RE: Submittal of the final Value Engineering Report
NHS-M001-00(533) Fulton County
PI No.: M001533
PBS&J Project Task Order No. 4

Value Engineering Study Report
I-75/I-85 Milling and Inlay Project,
Fulton County, Georgia

ALTERNATIVE NO.: **RI-1**

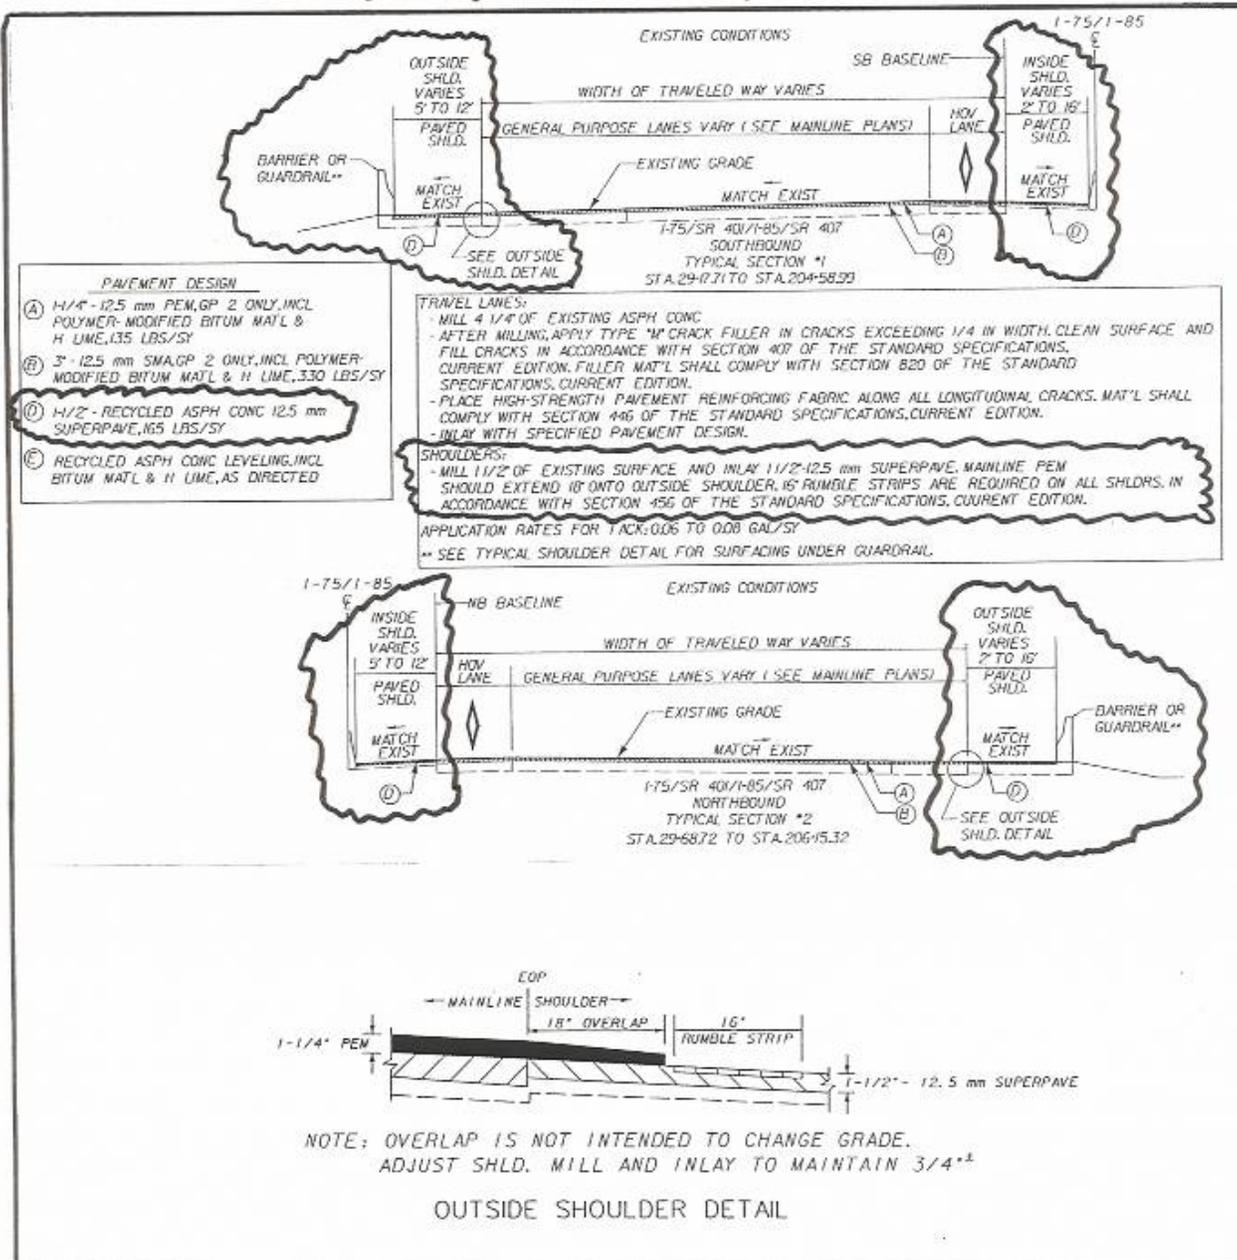
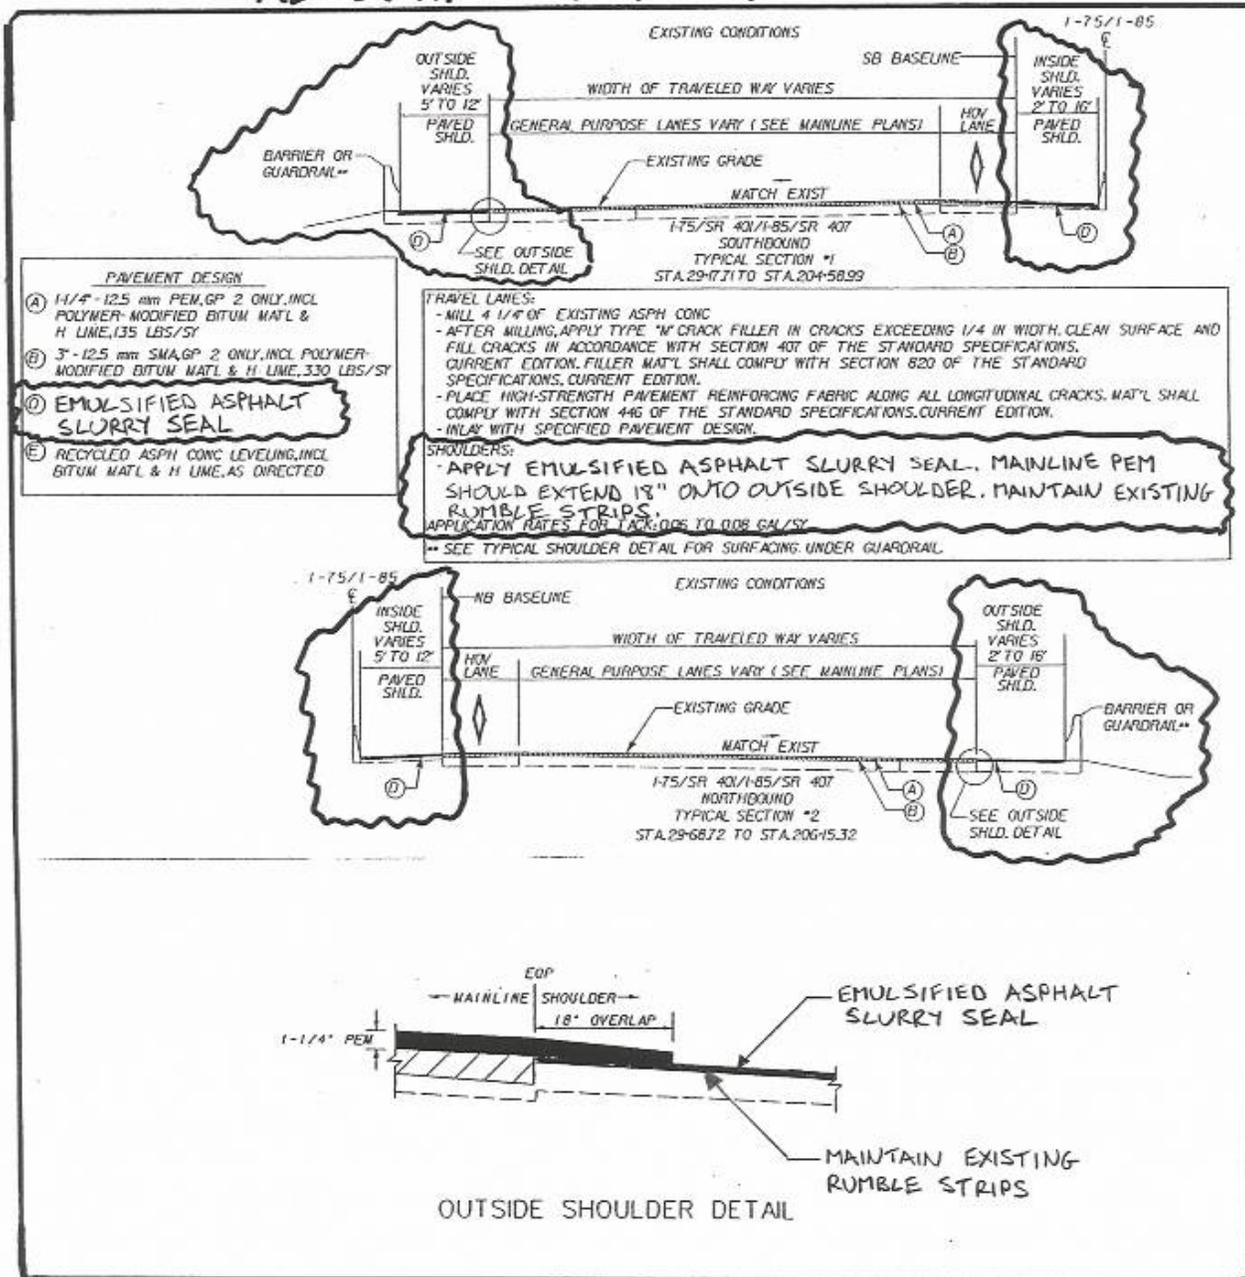
The original design calls for the milling and inlay of 1 ½” of pavement and the installation of 16” rumble strips along both the inside and outside shoulders.

This alternative design suggests to use an emulsified asphalt slurry seal along both the inside and outside shoulders in lieu of milling and inlay.

The GDOT shoulder recommendation presented in “addendum” dated May 26, 2006, recommends to mill and inlay the shoulders with a 1 ½” layer of pavement. Milling and inlaying the existing shoulders will also require the installation of new 16 inch rumble strips. During a site visit, the VE Team observed that the existing shoulders appeared to be in very good to excellent condition. Although it is normal construction procedures to replace the shoulders when rehabilitating the main travel lanes, as the existing shoulders are extremely wide in many areas due to the physical bounds of the roadway, it may be reasonable retain and rehab them in place.

ORIGINAL DESIGN R-2

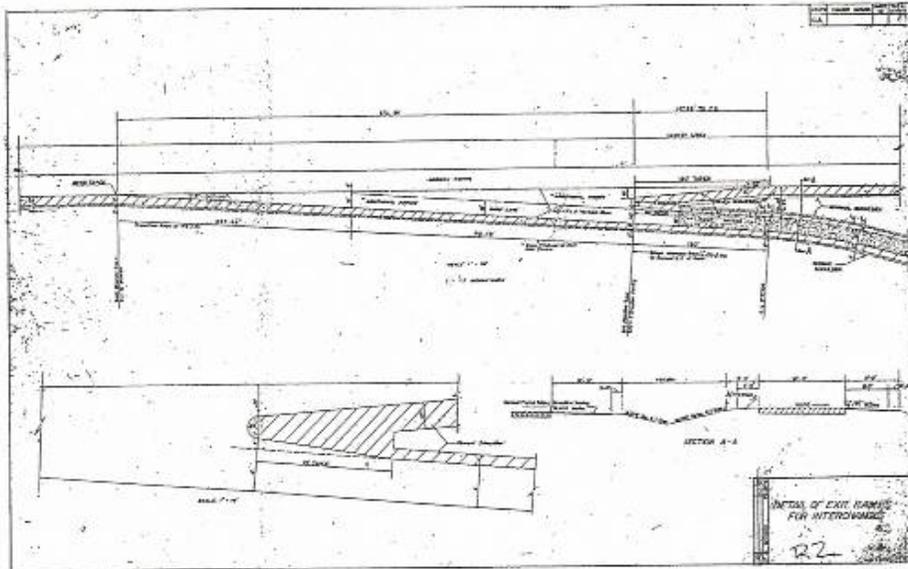
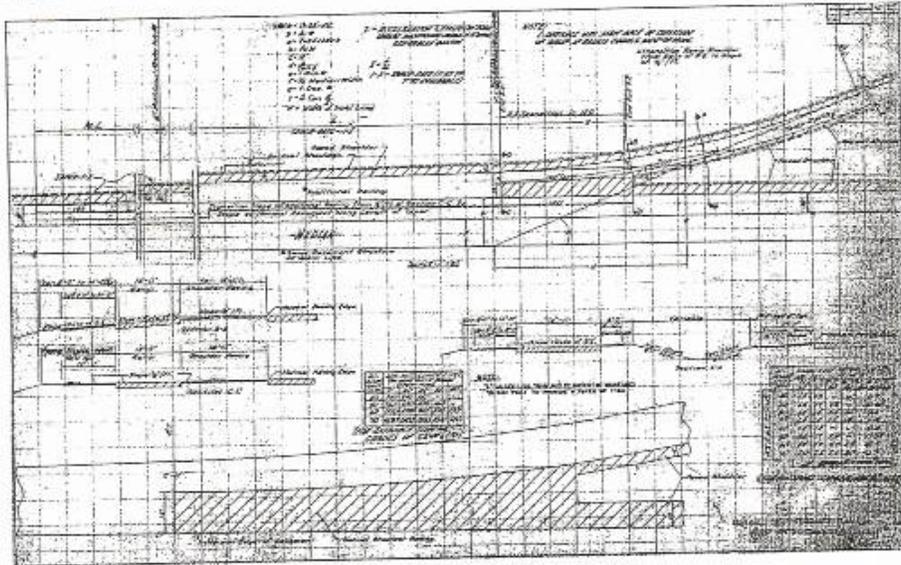
The original design calls for the contractor to mill and inlay the ramp and gore areas from the gore point to the mainline taper as shown on GA. Standard Construction Details R1,R2, R3 or as directed by the engineer

This alternative design suggests retaining the existing pavement in the Gore Areas and applying an emulsified asphalt to correct any oxidation of the existing material.

This alternative idea suggests that the gore areas, as they are outside the normal travel lanes may have not deteriorated and may still meet current standards for construction.

ORIGINAL DESIGN R-1

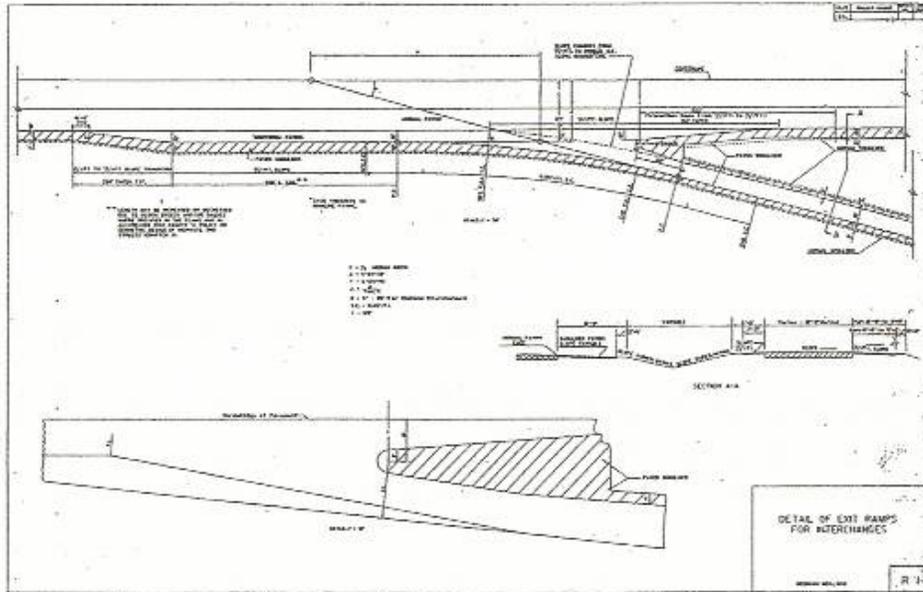
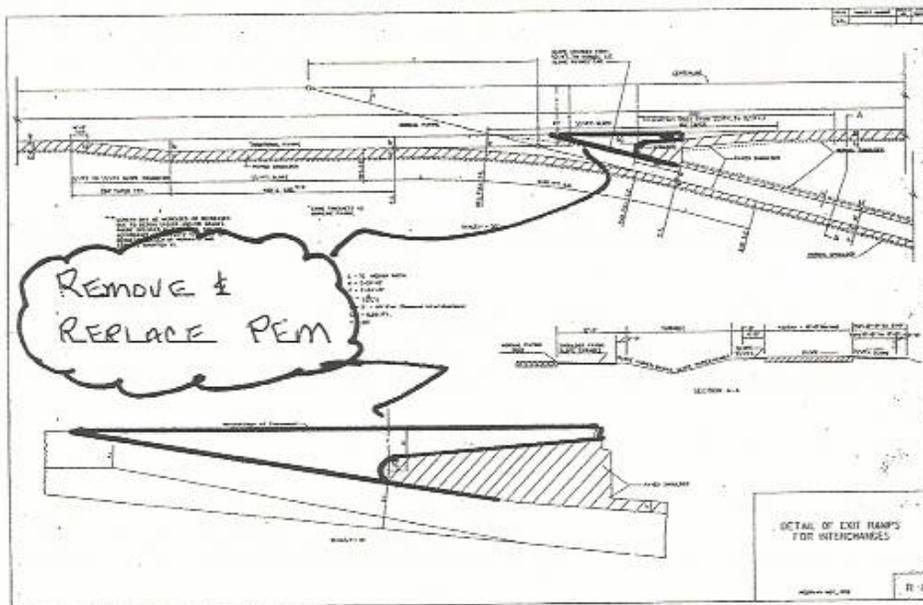
The original design calls for the contractor to mill and inlay the ramp and gore areas from the gore point to the mainline taper as shown on GA. Standard Construction Details R1,R2, R3 or as directed by the engineer

This alternative design suggests only milling and inlaying the existing PEM from the Gore Areas and not replacing the existing underlying structural asphaltic concrete.
